**Review and Comments on Selected Statements Contained in
the November 14, 1989 Letter of the Governor of Nevada to
the Secretary of Energy that Bear on Human Interference from
a Natural Resources Perspective**

Russell G. Raney

U.S. Department of the Interior, Bureau of Mines

U.S. Nuclear Regulatory Commission

FIGURE 1.— Map showing the location of the Yucca Mountain Addition and of mining districts and other areas discussed in the comments

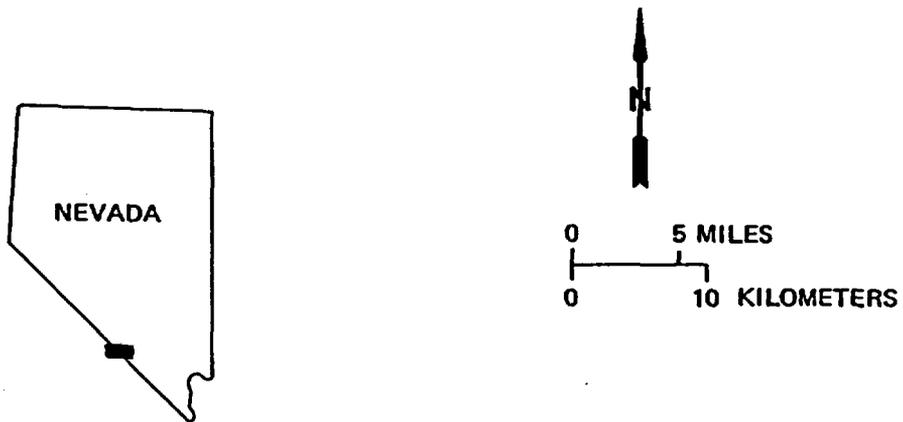
Reviewer's note: While not specifically stated in Governor Bob Miller's letter of November 14, 1989 to James D. Watkins, Secretary of Energy, it is assumed from the text (copy attached) that the Yucca Mountain area (also referred to in the letter variously as the "Yucca Mountain region" or "Yucca Mountain vicinity") is that area extending from Mine Mountain in the east to the Bullfrog Hills in the west, and from the southern part of Timber Mountain in the north to U.S. Highway 95 in the south. For purposes of consistency and clarity, the area defined above will be referred to here as the "Yucca Mountain Area" and includes Mine Mountain, the Calico Hills, Wahmonie area, Yucca Mountain, Crater Flat, Bare Mountain, the Bullfrog Hills, and the Rhyolite area (Figure 1).

FIGURE 2.— Generalized geologic map of the Bare Mountain (Fluorine) mining district showing principal mines

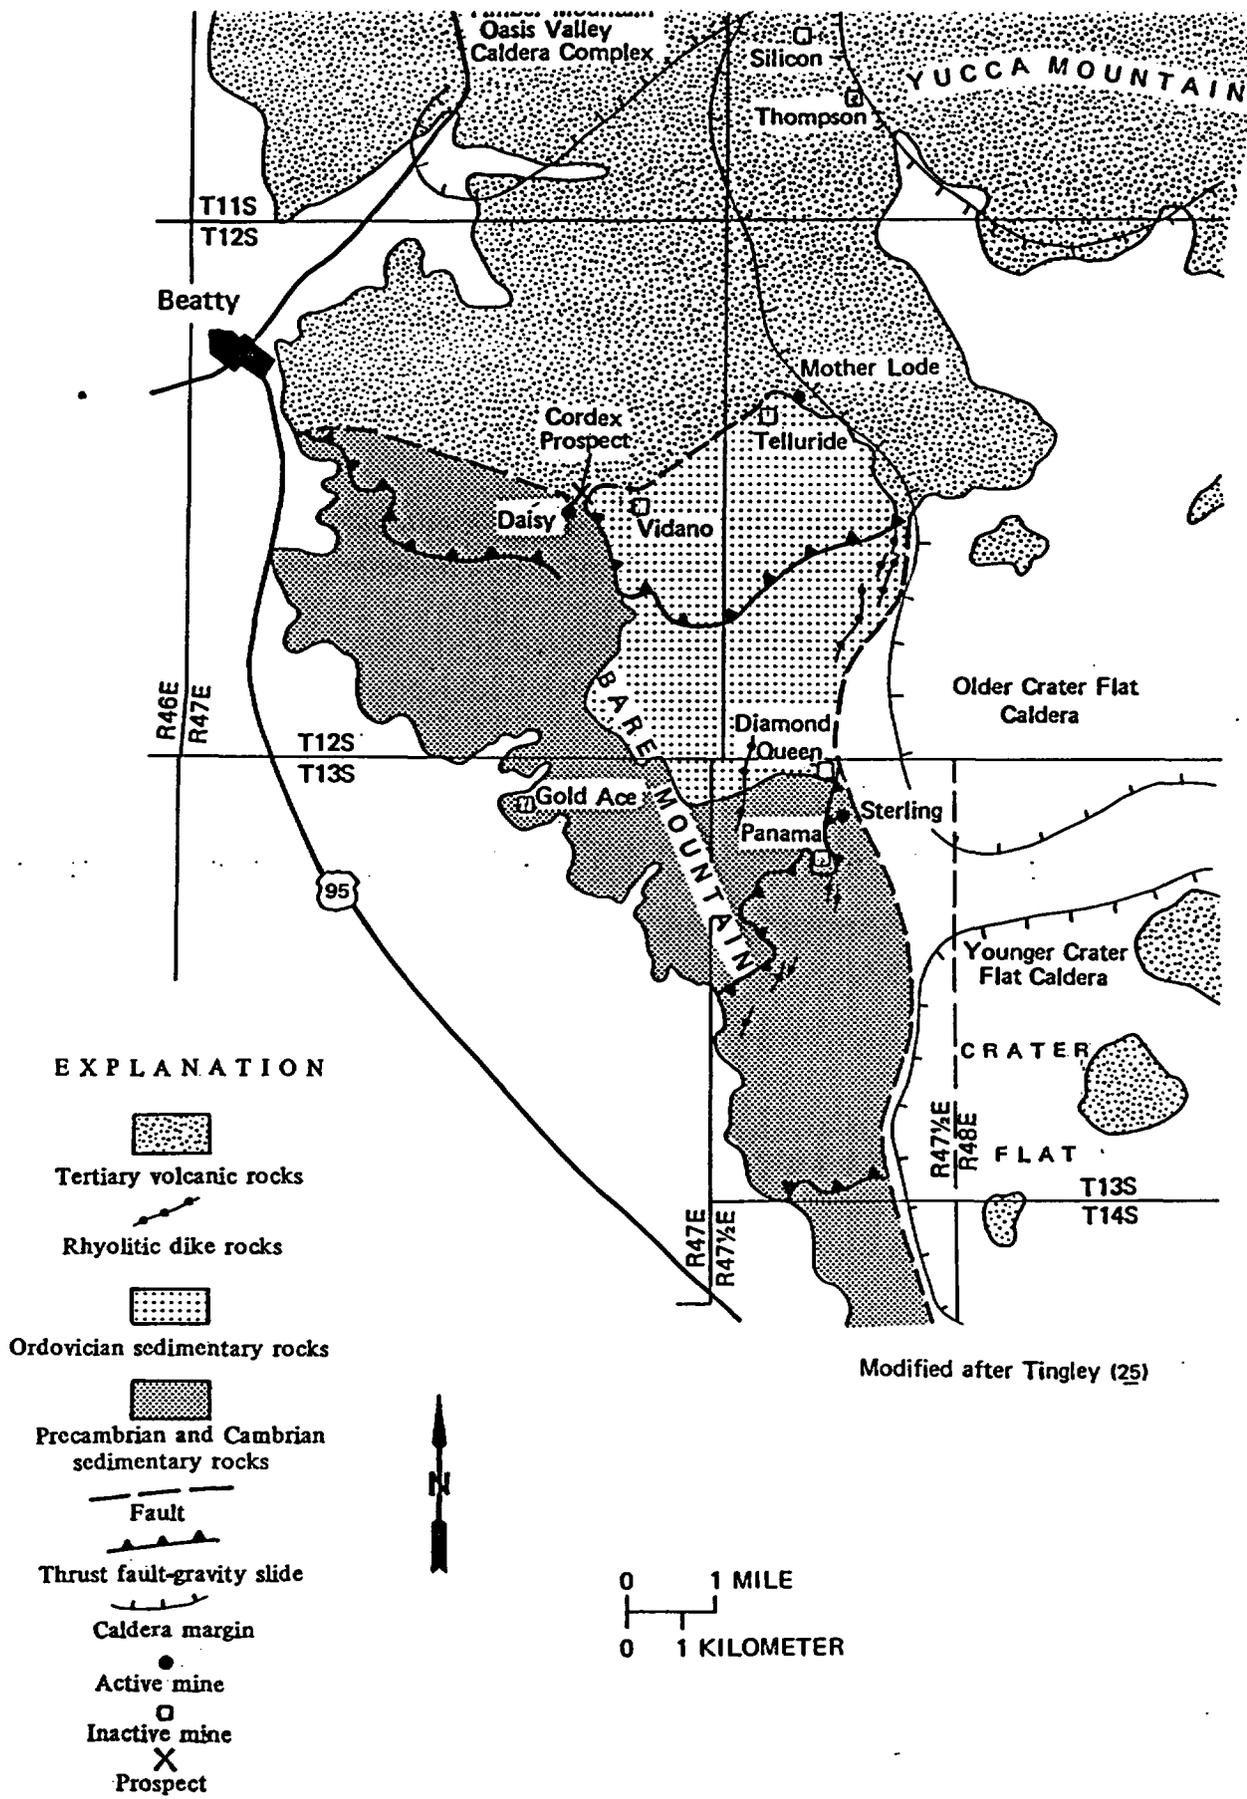
Epithermal gold and fluorite mineralization at the Sterling, Mother Lode, Daisy (Crowell) Fluorite, Cordex prospect, and other properties along the northern and eastern margins of Bare Mountain (Figure 2), and probably in the Wahmonie District, is related to subjacent porphyry-type magmatic systems about 13 to 13.5 million years in age (Ma) (4, page 77). Hydrothermal alteration, including argillization, silicification, with strong oxidation and exposures of Tertiary or Mesozoic granitic rocks, is reported by Quade and Tingley (2) in the Wahmonie area; Smith (5) and Hoover (6) report the possible existence of a shallow unexposed pluton at Wahmonie.

Gold was discovered on the east slope of Bare Mountain about 1905. Production of gold ensued in this area between 1913 and 1915 (3, page 4). The Bare Mountain (Fluorine) District has produced small amounts of mercury; fluorite has been produced at the Daisy (Crowell) (Figure 2) mine more or less continually since 1919.

Cordex Exploration Co. recently announced the discovery of a new gold/silver deposit near the Daisy (Crowell) Fluorite mine in Fluorspar Canyon on the northern flank of Bare Mountain (Figure 2). Of the three mineralized zones discovered, two occur in Cambrian sedimentary rocks and one in Miocene ash-flow tuffs. The volcanic rocks are strongly propylized, silicified, and argillized. Arsenic, antimony, mercury, and thallium occur in anomalous amounts (18, page 77-78). Figure 4 shows the spatial relationship between Bare Mountain and Yucca Mountain.

FIGURE 3.— Simplified geologic map of Bullfrog Hills area

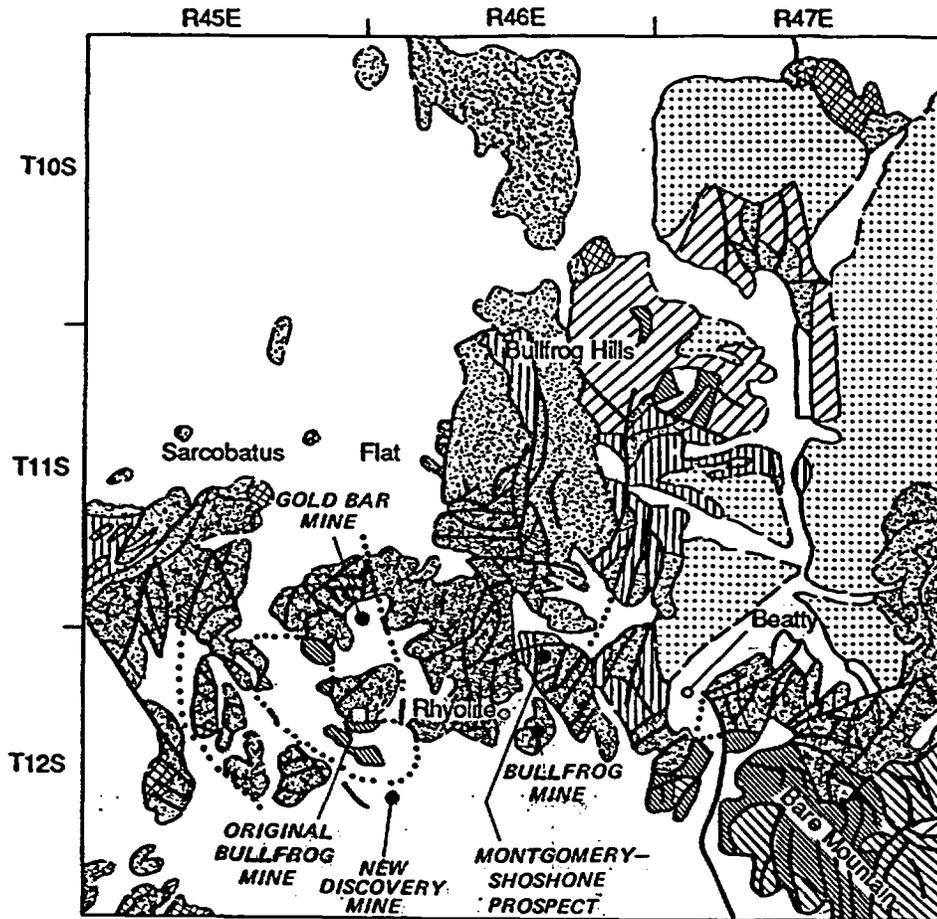
The "Bullfrog Mining District", also known as the "Rhyolite Mining District" and the "Pioneer Mining District", covers the Bullfrog Hills north and west of Beatty, Nye County, Nevada (Figure 3). Gold was discovered at the Bullfrog mine ("Original Bullfrog", SE1/4 Sec. 12, Twn. 12 S., Rng. 45 E.) at the south end of Bullfrog Mountain (about 11 km west of Beatty within the boundaries of Death Valley National Monument) in 1904. The principal ore body of the Bullfrog District occurred in the Montgomery-Shoshone mine (NE1/4 Sec. 10, Twn. 12 S., Rng. 46 E.) about 5 km west of Beatty. As stated above, St. Joe American recently developed new reserves at the Montgomery-Shoshone and discovered a new ore body near Ladd Mountain ("New Bullfrog", "Bond-Bullfrog", "Bullfrog", Sec. 15, Twn. 12 S., Rng. 46 E.). It appears that St. Joe sold (leased?) its interests to Bond Gold Inc., hence "Bond-Bullfrog." Nevada Bureau of Mines and Geology Special Publication 10 lists on page 21 a "Bullfrog" mine operated by Bond Gold Bullfrog Inc. of Beatty.

In summary, it appears that the "Bullfrog", "New Bullfrog", and "Bond-Bullfrog" are alternate names for the same property in Sec. 15, Twn. 12 S., Rng. 46 E. within the Bullfrog (Rhyolite) mining district in the Bullfrog Hills.

FIGURE 4.— Bedrock map showing spatial relationship of principal mines on Bare Mountain to Yucca Mountain

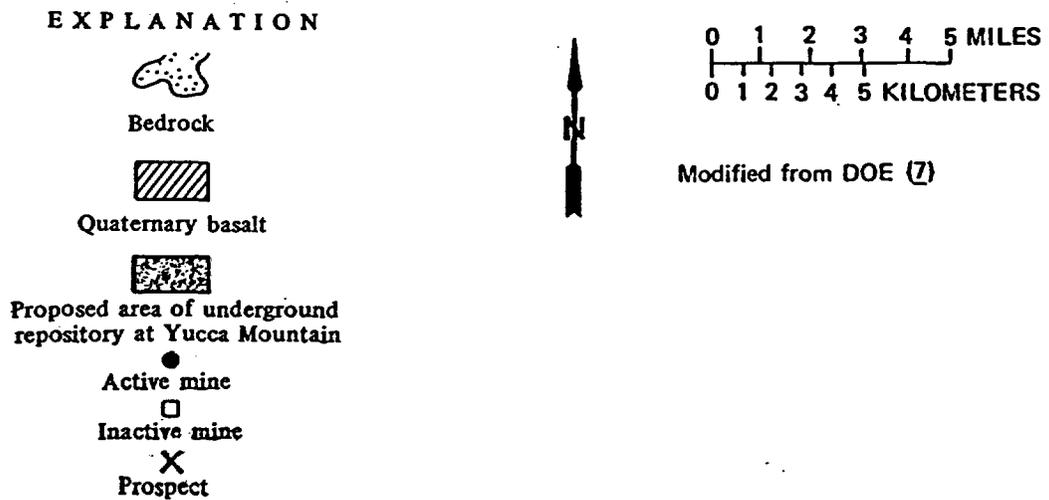
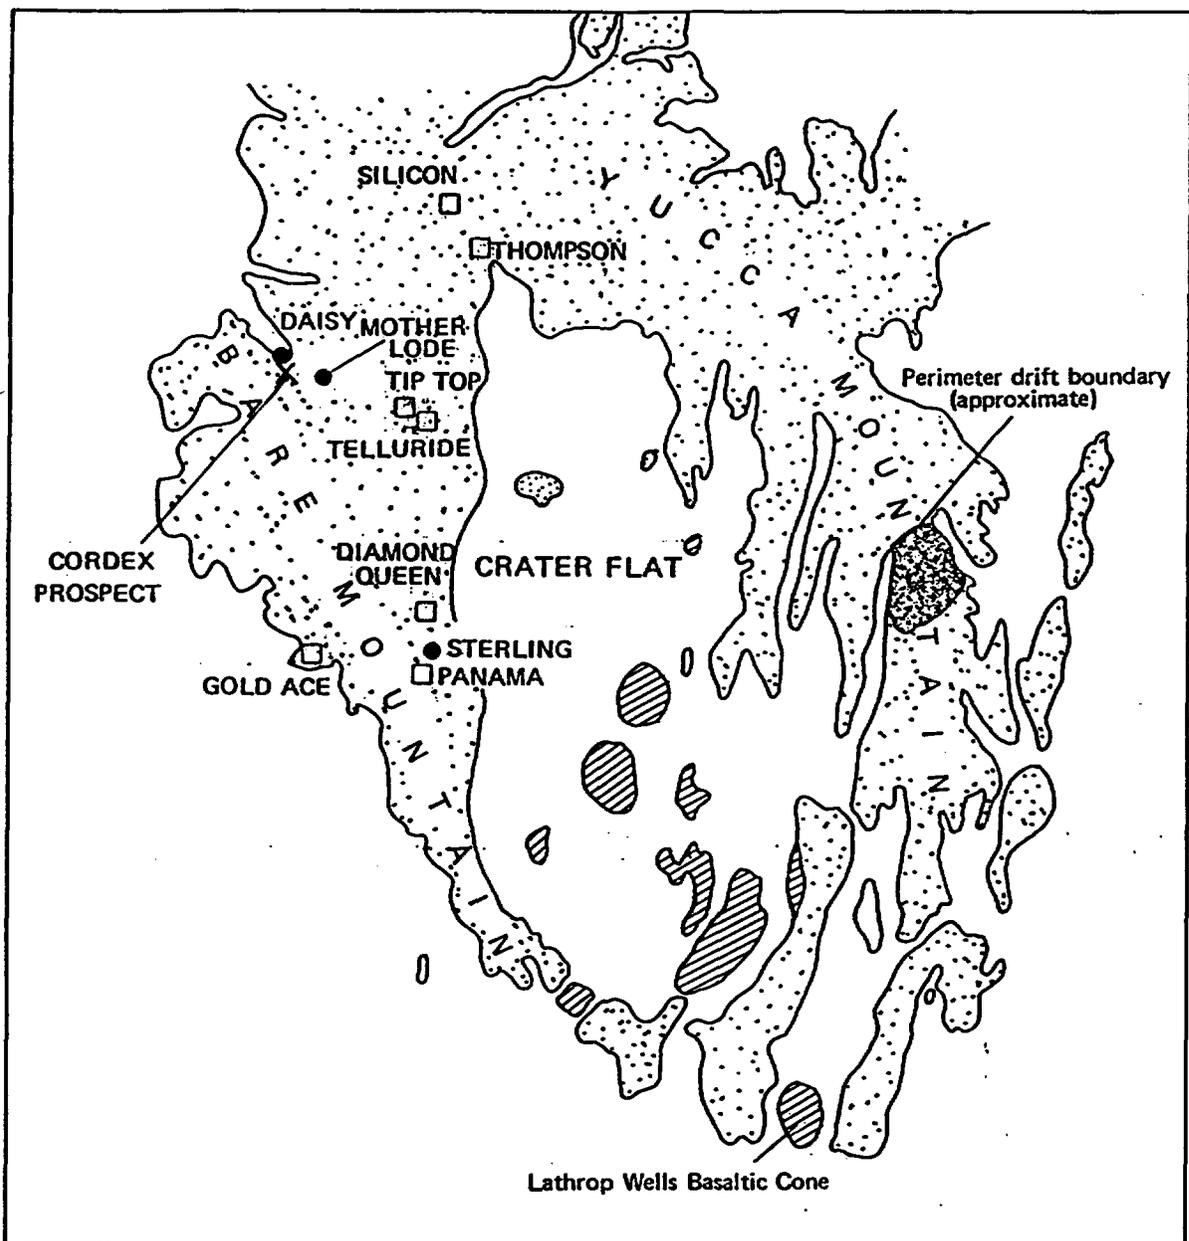
In 1980, the Bare Mountain (Fluorine) District was revitalized with the discovery of disseminated gold at the Sterling (Panama-Sterling) mine (Figure 4). The deposit has produced between 7,000 and 9,000 oz gold per year since it came on line in 1984 (3, page 4). GEXA Gold Corp. announced the discovery of its Mother Lode deposit on Bare Mountain in 1988. The deposit reportedly has reserves of about 4.4 million tons averaging 0.054 oz gold/ton. The Mother Lode deposit reached commercial production levels in February 1990 when 2308 oz of dore (gold and silver bullion) were poured containing 90 percent gold (17).
